Planning Commission Staff Report

Location: 633 S. Goddard Ave.

Description: **633 S. Goddard Ave. (Architectural Specialty Lighting Package)**: An Architectural Specialty Lighting Package for a 5.50-acre tract of land zoned "M3" – Planned Industrial District, located on the west side of Goddard Avenue, south of its intersection with Chesterfield Airport Road.

Legacy Performance Academy
 Chesterfield, MO
 50/30 Fc

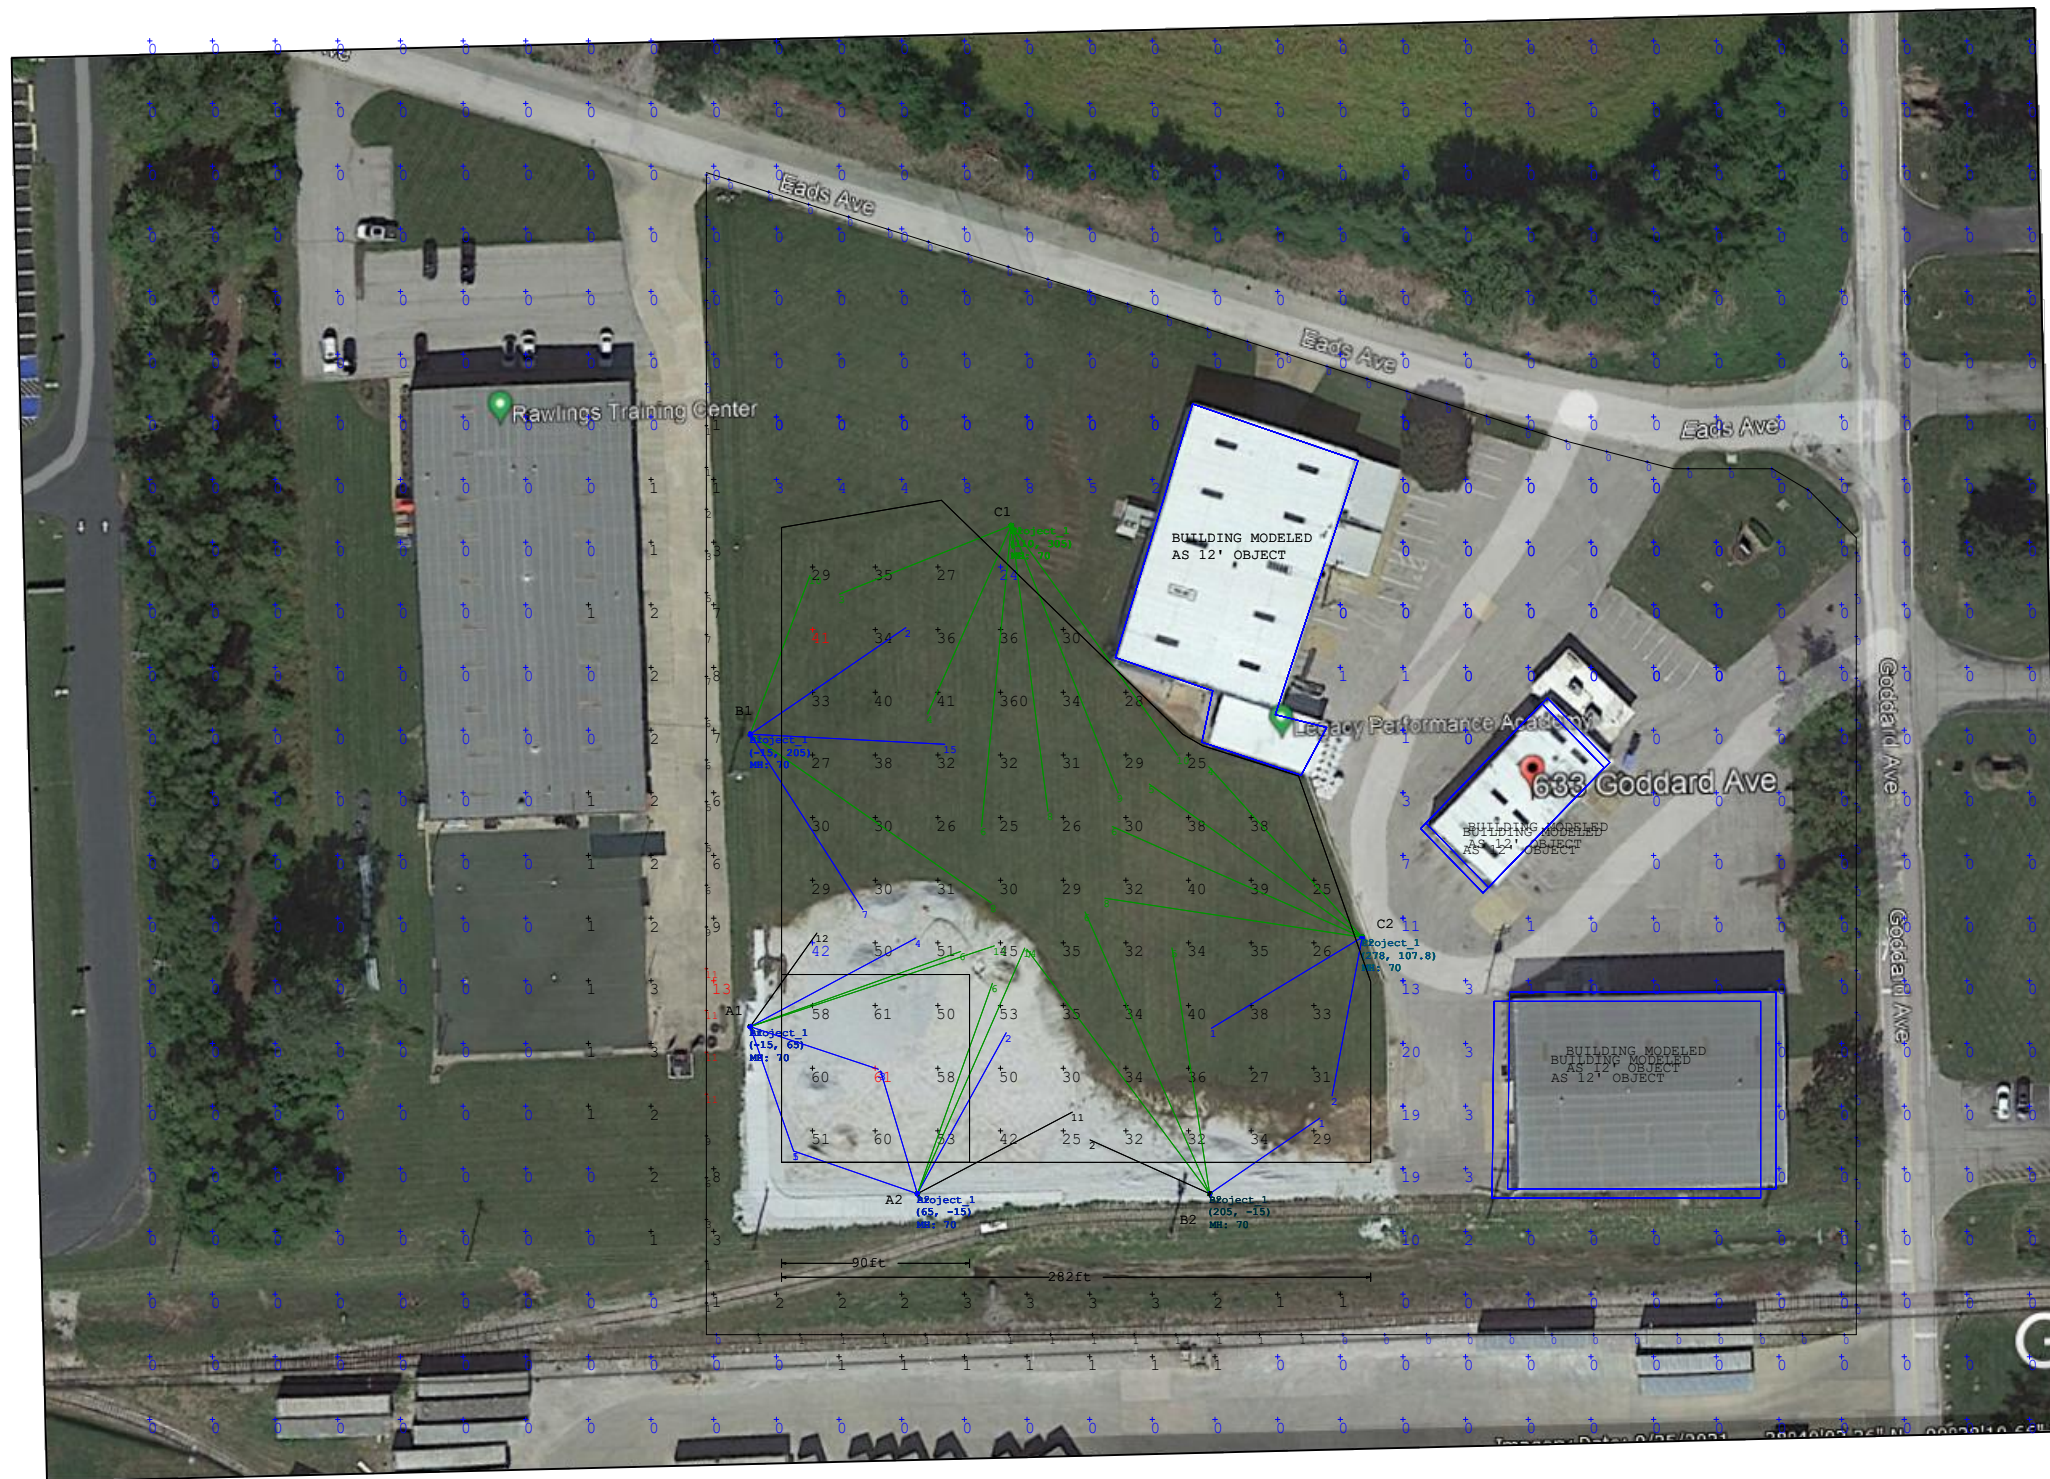
The Unified Development Code (UDC) provides criteria for both illumination level and mounting height for site lighting throughout the city. As per UDC, all commercial illumination is limited to a maximum of 8 foot-candles (Fc). Specific exceptions to this requirement are made for certain uses, such as ATMs and gas station canopies. The applicant is requesting an illumination level reaching maximum of 61 Fc in some areas of the plan. The average illumination level ranges from 30-50 Fc.

Code also states that all outdoor lighting for recreational facilities must be fully shielded to prevent light spillage and glare. The proposed fixture includes a partial shield to direct illumination on to the multi-purpose field. However, spillage onto an adjacent property is shown levels as 0 to 2 Fc, as indicated on the plan.
